**OPTIONAL SERVICE BULLETIN NO. DAC1-61-01 REV. 5**

SUPERSEDES DAC1-61-01 REV. 4

Type: DA 20-C1

This service bulletin addresses the Sensenich propeller installation.

Figure 2. Recommended configuration, Sensenich W69EK-63, W69EK-63G, or W69EK7-63GM, 7/16" diameter attachment bolts.

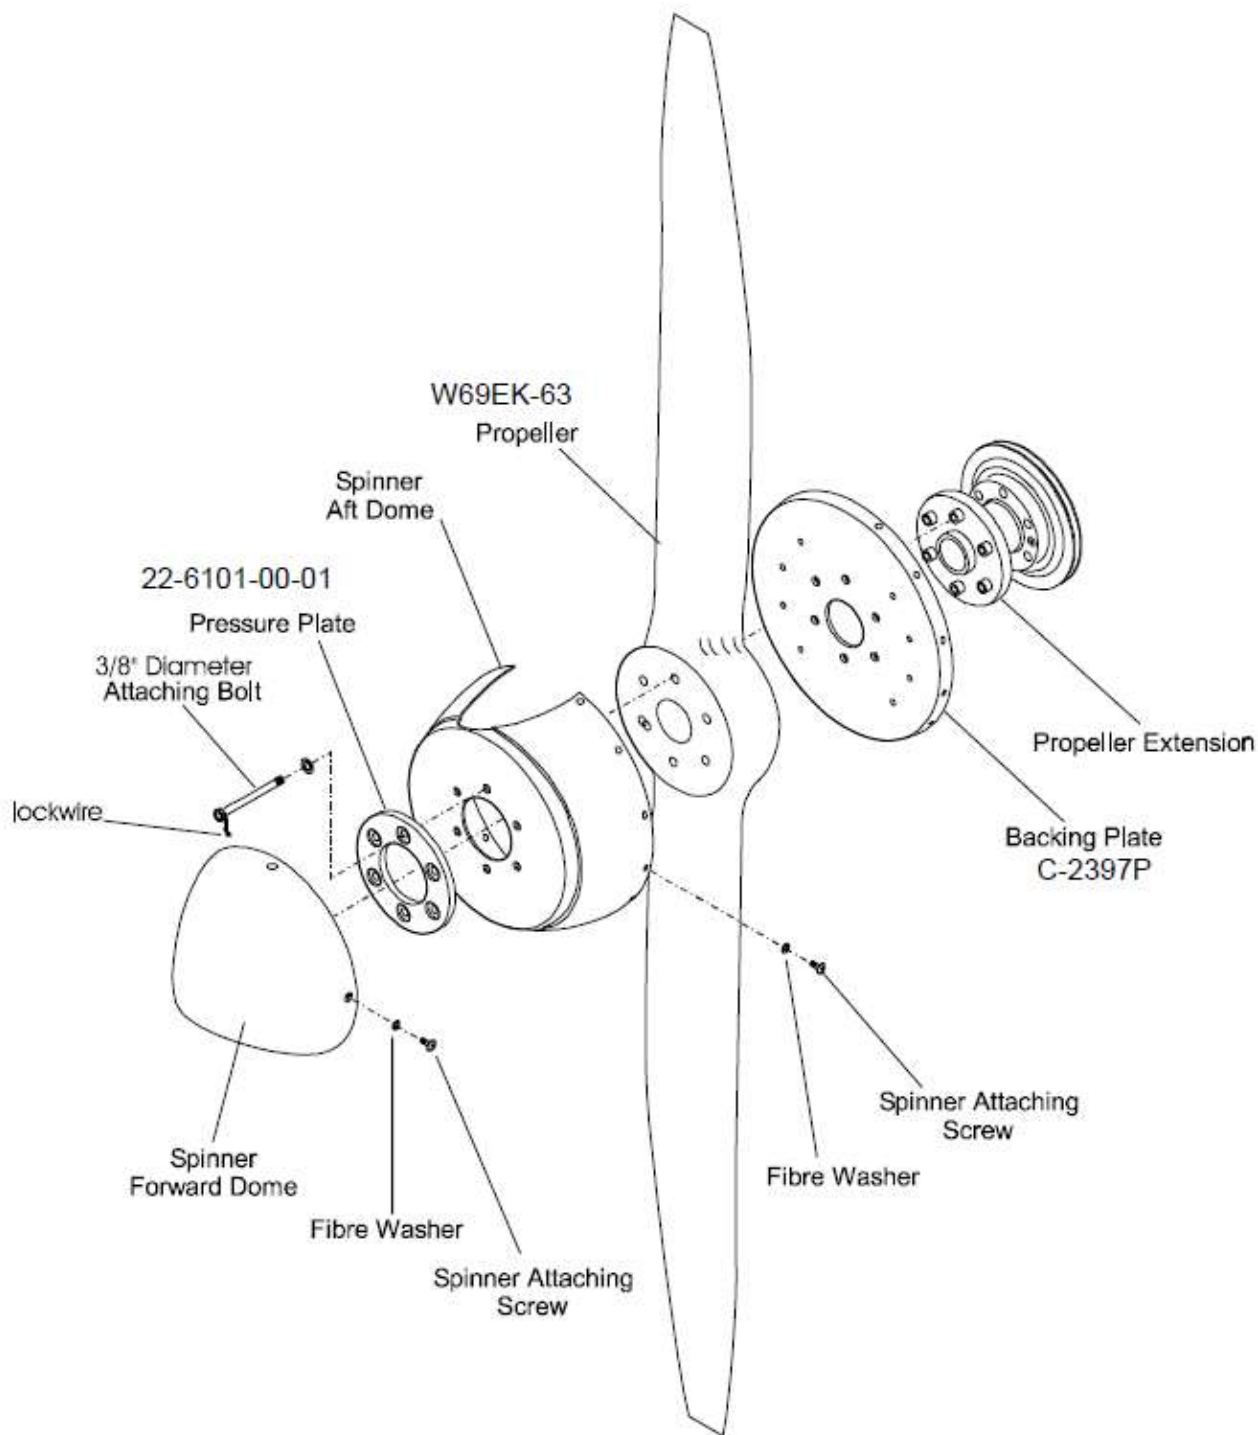
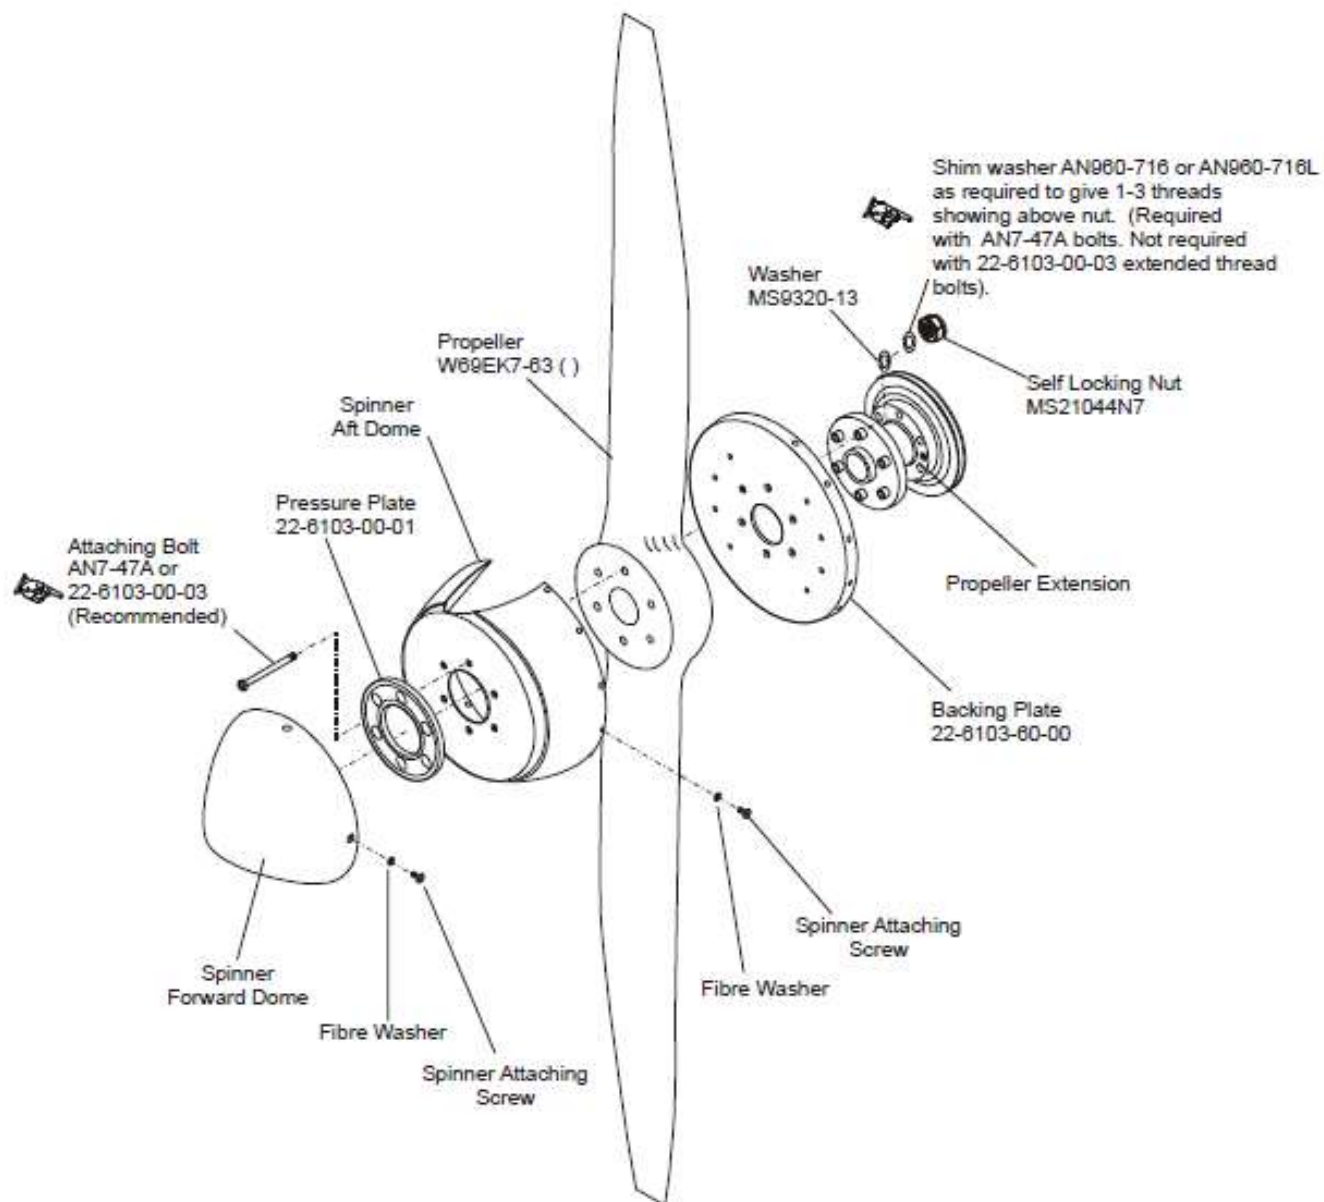
This revision adds the use of special extended thread 7/16" attachment bolts (P/N 22-6103-00-03) as an alternative to the AN7-47A bolts. These extended thread bolts do not require AN960-716 or AN960-716L shim washers to ensure proper thread engagement. The extended thread bolts are identified by the "D, A and X" letters on the head. A Part III has been added to this bulletin to provide the procedure for replacing the AN7-47A bolts with the extended thread bolts.

PART I – Describes the procedure for the replacement of propellers with 3/8" attachment bolts with a propeller that uses 7/16" diameter attachment bolts (AN7-47A or 22-6103-00-03). This installation increases the clamping force of the propeller and allows torque inspection without the removal of the forward spinner dome.

1. Remove the engine cowlings.
2. Remove the W69EK-63 propeller as per AMM Chapter 61.
3. Remove the six bushings in the propeller flange using the removal/installation tool as shown in Figure 3.

5. Clean the bushings and the bushing bores in the propeller adapter using denatured alcohol.
6. Install the new (7/16" ID) bushings into bores using Loctite 609 and the installation tool. Ensure the bushings are completely pulled through the propeller flange. Reference Figure 3 for these instructions.

7. Clean the propeller adapter flange (mating surface for propeller) with de-natured alcohol.
8. Clean the propeller hub faces with de-natured alcohol.
9. Install the W69EK7-63, W69EK7-63G, or W69EK7-63GM propeller in accordance with the Sensenich Installation Manual (Doc. W69EK7-CF Rev. F, or later). If using AN7-47A bolts, install AN960-716 or AN960-716L shim washers as necessary under the attachment nut to ensure 1-3 threads are showing above the nut. If using 22-6103-00-03 extended thread bolts, then it is allowable if more than 3 threads are showing; AN960-716 or AN960-716L shim washers are not required.
